RESOLUTION NO. 543-09

A RESOLUTION OF THE CITY COUNCIL OF THE CITY OF ORANGE CITY, FLORIDA, ACKNOWLEDGING AND APPROVING A 12-MONTH EXTENSION TO THE DEVELOPMENT ORDER FOR THE SPARKMAN RIDGE PRELIMINARY SUBDIVISION PLAT AND SITE PLAN, WHICH WILL DIVIDE A 50.72-ACRE PARCEL INTO 94 SINGLE FAMILY RESIDENTIAL LOTS AND 108 TOWNHOUSE RESIDENTIAL LOTS, SAID PARCEL LOCATED ON THE NORTHWEST CORNER OF WEST RHODE ISLAND AVENUE AND SOUTH SPARKMAN AVENUE, ORANGE CITY, FLORIDA; REPEALING ALL RESOLUTIONS OR PARTS OF RESOLUTIONS IN CONFLICT HEREWITH; AND PROVIDING FOR AN EFFECTIVE DATE.

Exhibit B
Resolution 543-09
Sparkman Ridge Subdivision

Conditions of Approval

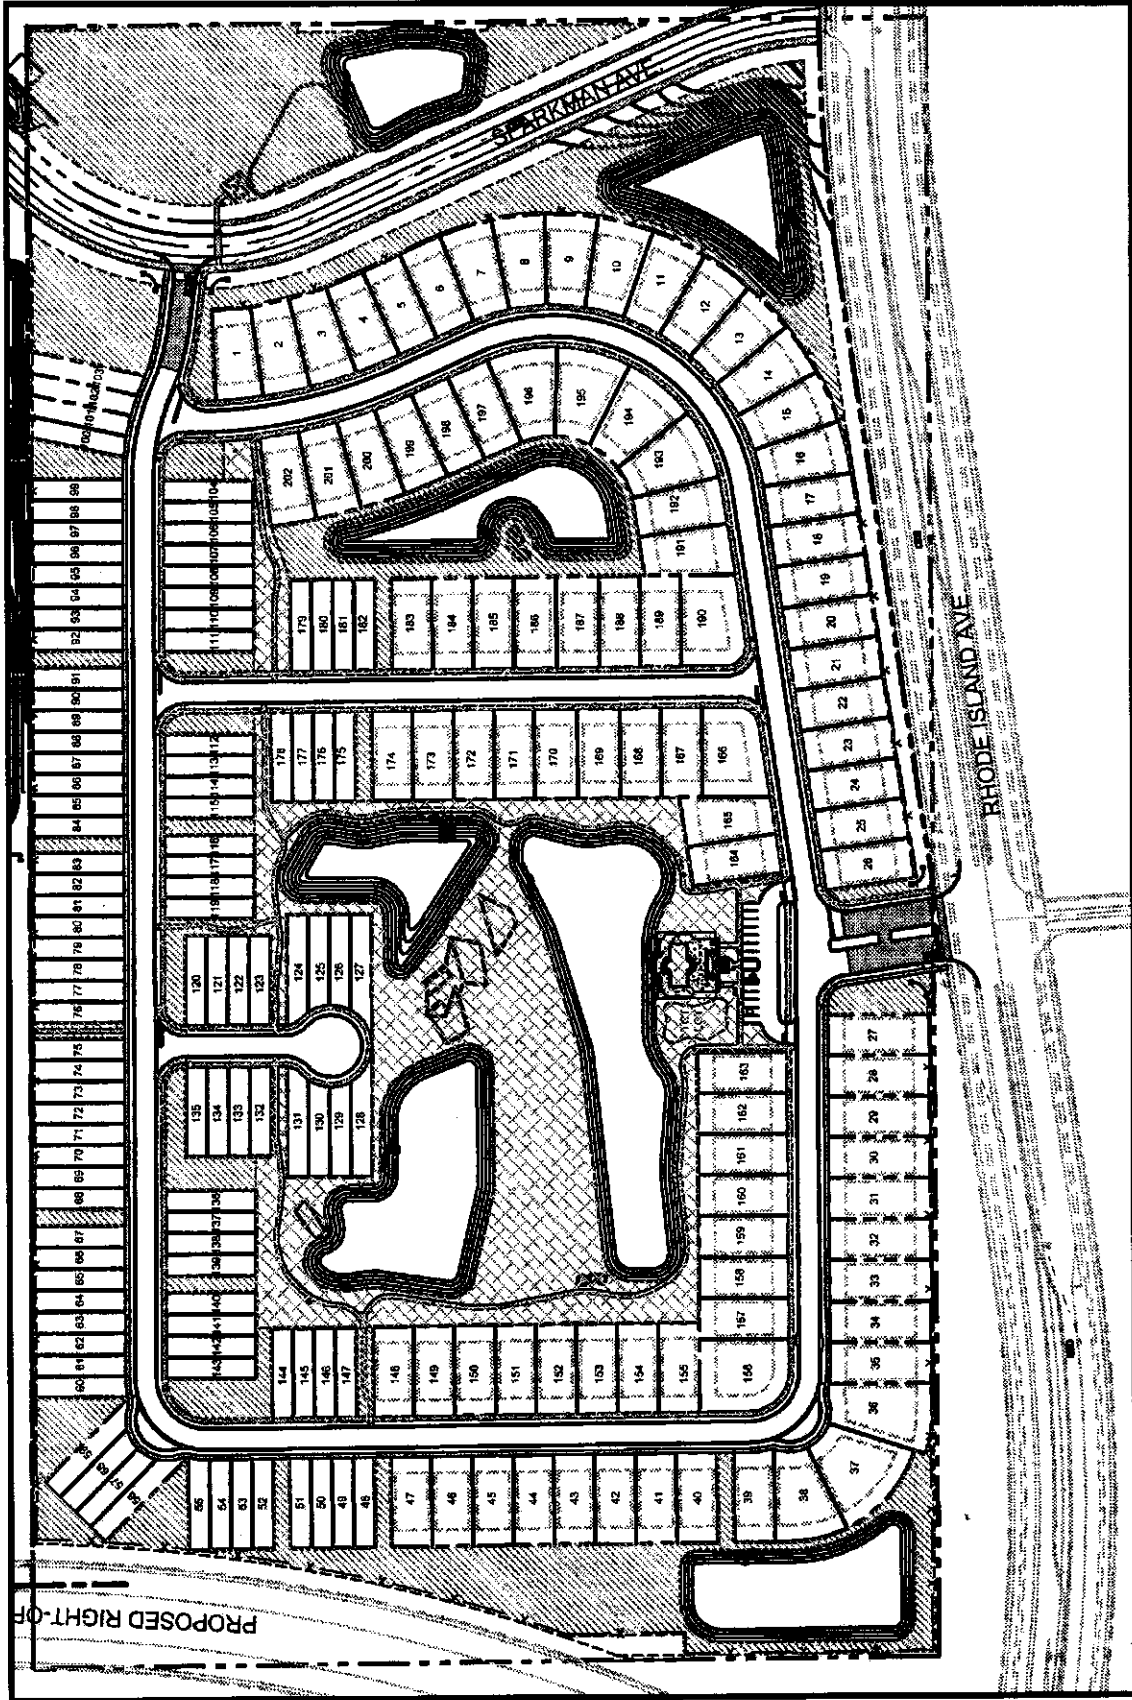
The City's land development code requires that townhouse building elevations must reflect a design consistent with the other proposed buildings. Building elevations were not submitted as required by Section 10 because the applicant is uncertain as to the ultimate townhouse design at this time. As a result, staff was not able to determine compliance with the appearance standards. **Staff recommends that at such time as the applicant is ready to develop the townhouse portion, the developer (of the townhouse portion) shall submit the townhouse building elevations required in Section 10 of the land development code, which will be reviewed and considered for approval by city staff prior to construction of the townhouses.** The applicant has agreed to this condition, which is noted on sheet 3 (note 27) of the site plan.

Building elevations for the mail kiosk, clubhouse, and cabana were not submitted as required by Section 10. The building elevations must reflect a design consistent with the other proposed buildings. As a result, staff was not able to determine compliance with the appearance standards. **Staff recommends that at such time as the applicant is ready to develop the mail kiosk, clubhouse, and cabana, the developer shall submit the mail kiosk, clubhouse, and cabana building elevations required in Section 10 of the land development code, which will be reviewed and considered for approval by city staff prior to the issuance of a certificate of occupancy on the first dwelling unit.** The applicant has agreed to this condition, which is noted on sheet 3 (note 28) of the site plan.

Staff is concerned about the proximity of the sinkhole to Sparkman Avenue, of which a cross section of the proposed Sparkman Avenue and the existing sinkhole is depicted on Sheet 8 of the site plan. It appears that the sinkhole slope may be too close to the edge of the road, and fencing may be required. The need for a fence and/or other safety precautions will be determined by the City Engineer at time of street construction. **Staff recommends approval of the site plan subject to the developer providing an architectural fence to be installed at the sinkhole location, if, following construction of Sparkman Avenue, it is determined by the City Engineer that a fence, or other suitable safety precaution, is required because of the sinkhole slope or proximity.**

Staff is concerned about certain issues that had arisen in another subdivision, which were caused by 50-foot wide lots (and the 5-foot setbacks) similar to those within the approved Sparkman Ridge R-PUD. These issues consist of the side setback, building separation, side yard slopes, retaining walls, and mechanical equipment locations etc. In one case, some contractors located the air conditioners side-by-side between two houses, therein making it impossible to operate a lawn mower between houses, or to gain emergency access. In some cases, grade differences required retaining walls.

The applicant was made aware of the above, and as a result, has added three notes (21, 22, and 25) to Sheet 3 of the site plan in an attempt to address the issues. However, these notes do not adequately address all the issues listed above.

Staff recommends approval of the site plan subject to (1) a minimum 10-foot separation between roof eaves; (2) a minimum ground slope ratio of 6:1 within any single side yard; (3) any ground slope in side yards steeper than 6:1 must install a retaining wall; (4) any retaining wall must be engineered and constructed of concrete or landscape block and not wood; (5) maintain a minimum clearance of 4-feet in any single side yard; and (6) locate all mechanical equipment in the rear yard.

The site plan depicts a detail of the fence that will visually screen the rear yards of all lots facing the Western Parkway, Rhode Island, Sparkman Avenue, and the north property line. However, this fence

detail on Sheet L1.2 depicts a 122-inch fence, whereas the maximum height is 6-feet within a residential development. **Staff recommends approval of the site plan subject to the fence maintaining a maximum height of 6-feet.**
